Re: Radford Army Ammunition Plant, Va.
Master Work Plan Addendums 020 & 021
Review of the Army's RCRA Work Plan Addendums

Subject: With Certification, Work Plan Addendum 020, RCRA Facility Investigation for Solid Waste Management Units 35, 37, 38 and Area of Concern Q, Final October 2007 and Work Plan Addendum 021, RCRA Facility Investigation at Solid Waste Management Unit 57, Final October 2007
Radford Army Ammunition Plant, EPA ID# VA1 210020730

Response to Comments (8/24/2007)
EPA and VDEQ Comments Received via e-mail 07/06/07
Draft Work Plan Addendum 020, RCRA Facility Investigation for Solid Waste Management Units 35, 37, 38, and Area of Concern Q, Radford Army Ammunition Plant, Virginia, April 2007

FIGURE 2-1

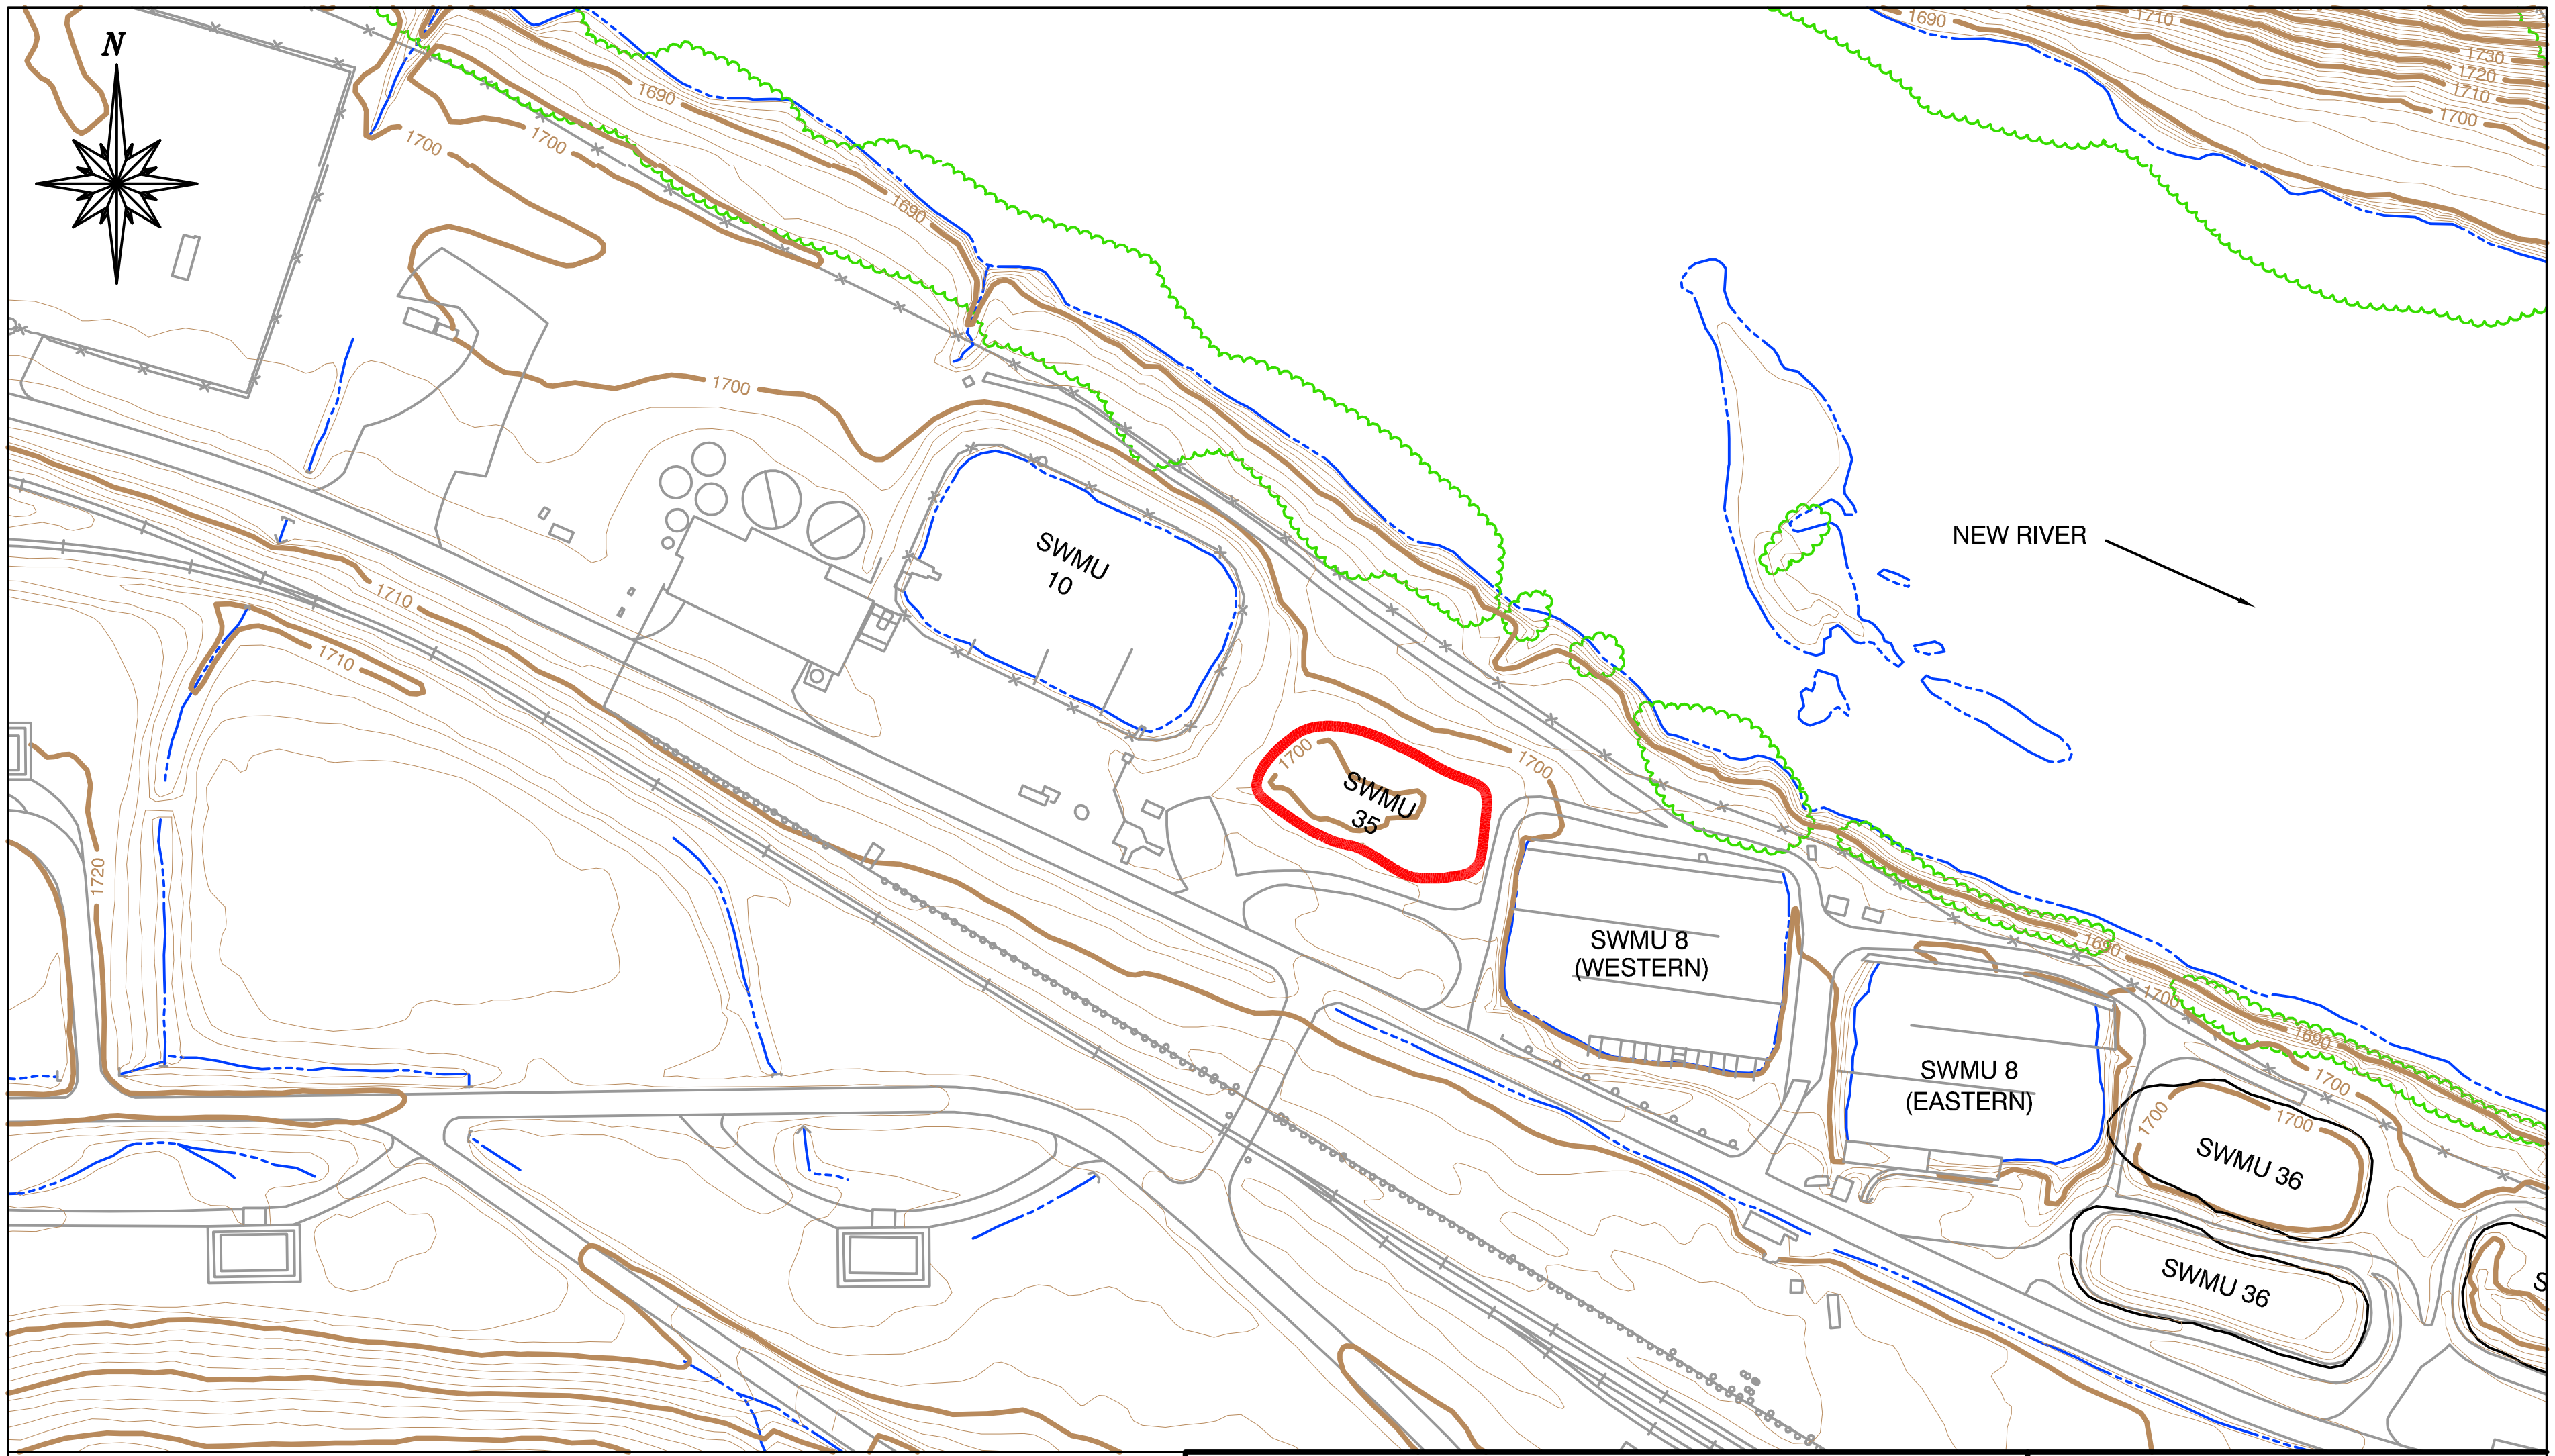
Comment 1: Several important site features do not appear to have been identified on the site figures. For example, Figure 1-2 (Topographic Map) does not label Building 4931 even though a terra cotta pipe connects this building to Solid Waste Management Unit (SWMU) 57. Additionally, the drainage swale that surrounds SWMU 57 and then connects to a drainage way to the northwest has not been labeled. Please revise the Work Plan Addendum to include a site figure which includes these important site features.

> **RFAAP Response:** Figure 2-1 will be revised to identify the location of Building 4931, the location of the drainage ditch that surrounds SWMU 57, and the location of the drainage way extending to the northwest of SWMU 57.

FIGURE 2-8

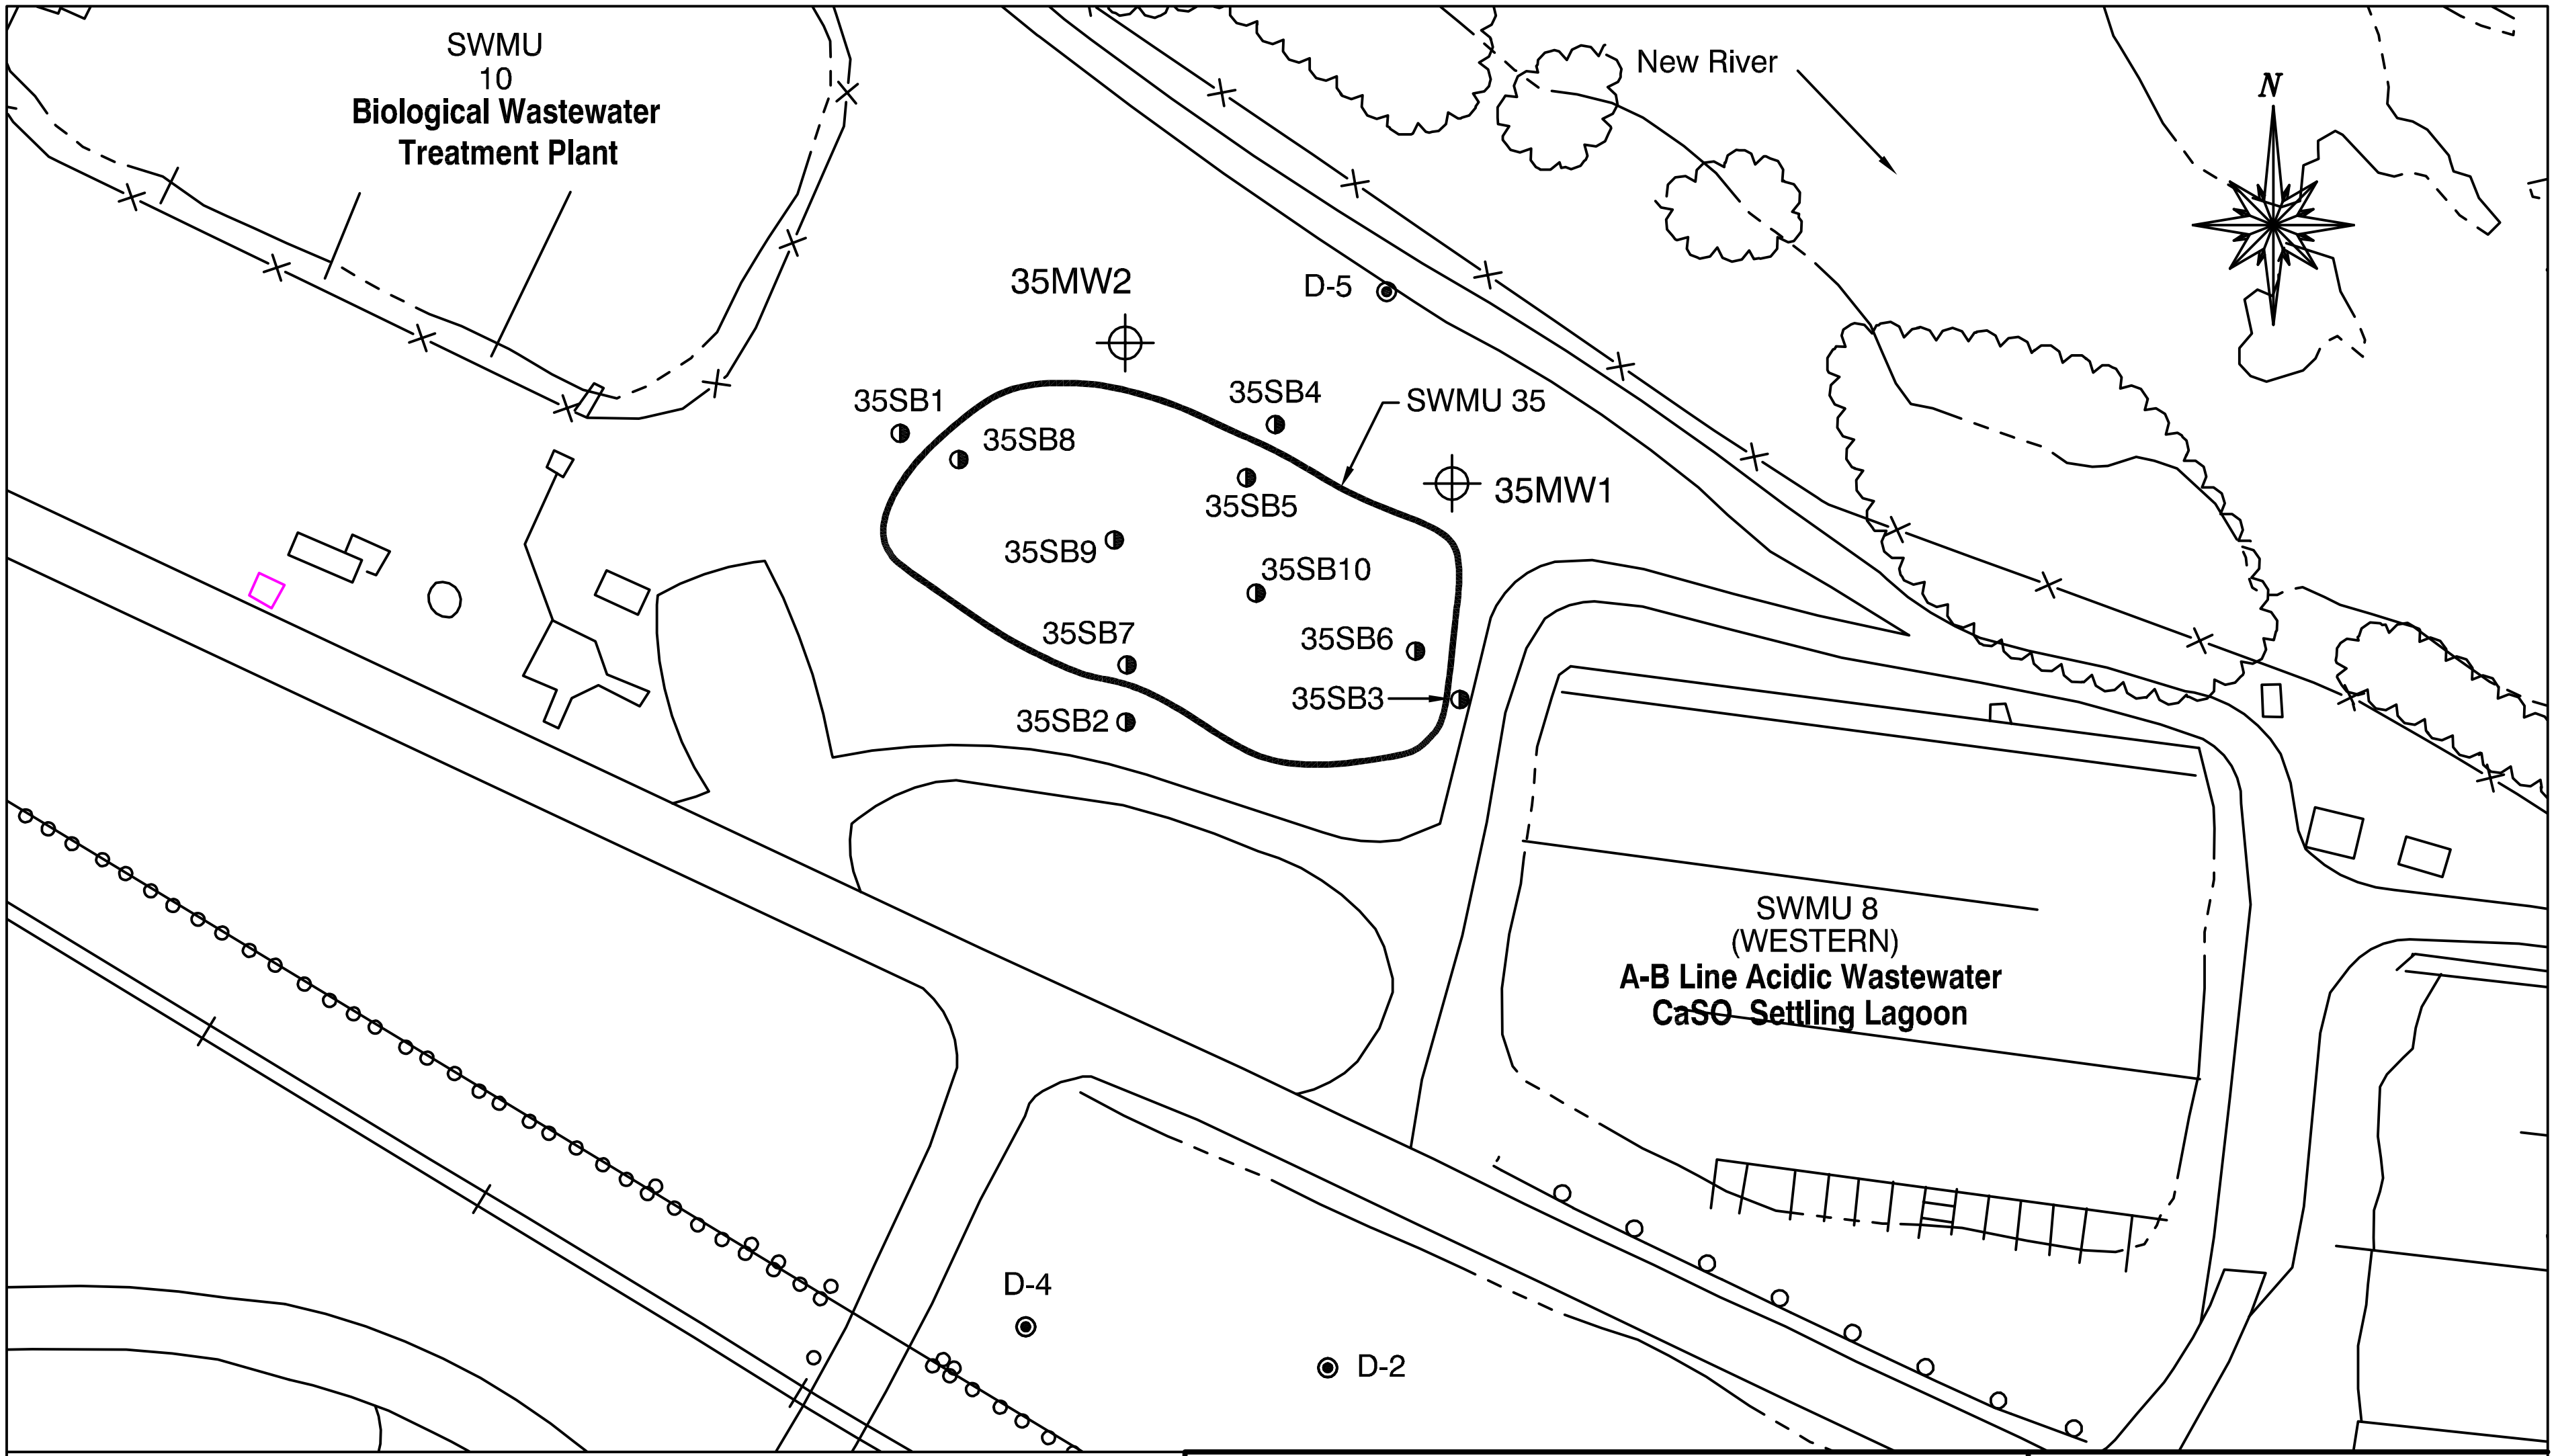
Comment 3: Section 2.6.1.1, Inside Drying Bed Areas, Page 2-8: One of the six proposed soil borings is identified as 35SB57. This sample could not be located on Figure 2-8 (RFI Proposed Sampling Locations SWMU 35). Figure 2-8 does include a sample identified as 35SB5, so it appears a typographical error may have been made in the text of the document. Please resolve this discrepancy.

Comment 6: Section 2.6.1.1, Inside Drying Bed Areas, page 2-8: There appears to be a discrepancy between the text in sections 2.6.1.1 and 2.6.1.2, and Table 4-4 and Figure 2-8. Section 2.6.1.1 indicates that three samples will be collected from each of the six borings (35SB1 through 35SB6) for chemical analysis. However, Table 4-4 which is referenced in this section lists only one surface sample (0-1 ft bgs) each from boring locations 35SB1 through 35SB4. Table 4-4 appears to match boring locations depicted on Figure 2-8. Likewise, section 2.6.1.2 indicates that one surface soil sample (0-1 ft bgs) will be collected from each of the four borings (35SB7 through 35SB10) for chemical analysis. However, Table 4-4 appears to indicate that three samples will be collected from each boring for chemical analysis. Please resolve this discrepancy. One way would be to change the listing in the text (Section 2.6.1.1) for the borings inside the Drying Bed Areas to 35SB5, 35SB6, 35SB7, 35SB8, 35SB9 and 35SB10, and change the listing in the text (Section 2.6.1.2) for the borings outside of the Drying Bed Areas to 35SB1, 35SB2, 35SB3 and 35SB4.

Comment 7: Section 2.6.1.2, Outside Drying Bed Areas, Page 2-8: It appears that only surface soil sampling is proposed for outside of the drying bed areas. It is not clear that this limited sampling will be adequate to assess the presence or absence of sludge. Previous investigations have encountered a sludge thickness of up to 8 feet within the bermed area; however, areas outside of the berm do not appear to have been assessed (Page 2-3). Please revise the Work Plan Addendum to propose subsurface investigation and sampling outside the drying beds, or provide justification for not assessing subsurface conditions outside the presumed limit of the drying beds.

> **RFAAP Response:** The first sentence of Section 2.6.1.1 contains a typographical error. The boring listed as 35SB57 should be 35SB5. The text will be changed from 35SB57 to 35SB5.

RFAAP Response: The correct boring locations and identifications are shown on Figure 2-8 and Table 4-4. To resolve the identified discrepancies, the following text changes will be made:

- Section 2.6.1.1 – the first line of text in Section 2.6.1.1 will be changed to "Six soil borings (35SB5, 35SB6, 35SB7, 35SB8, 35SB9, and 35SB10) will be advanced within the drying bed area to the depth of encountered groundwater or refusal, whichever is shallower."
- Section 2.6.1.2 – the first line of text in Section 2.6.1.2 will be changed to "Four soil borings (35SB1, 35SB2, 35SB3, and 35SB4) will be advanced outside the perimeter/berm of the drying bed to a depth of 10 ft bgs to assess for the presence or absence of sludge outside the drying bed (Figure 2-8)."

RFAAP Response: The text of Section 2.6.1.2 will be revised as follows:

Four soil borings (35SB1, 35SB2, 35SB3, and 35SB4) will be advanced outside the perimeter/berm of the drying bed to a minimum depth of 10 ft bgs to assess for the presence or absence of sludge outside the drying bed (Figure 2-8). If sludge is encountered at a location, then additional borings will be completed to assess the horizontal and vertical extent of sludge outside of the drying bed. If sludge is encountered to depths of 10 ft, then borings will be extended deeper until the vertical extent of sludge has been delineated.
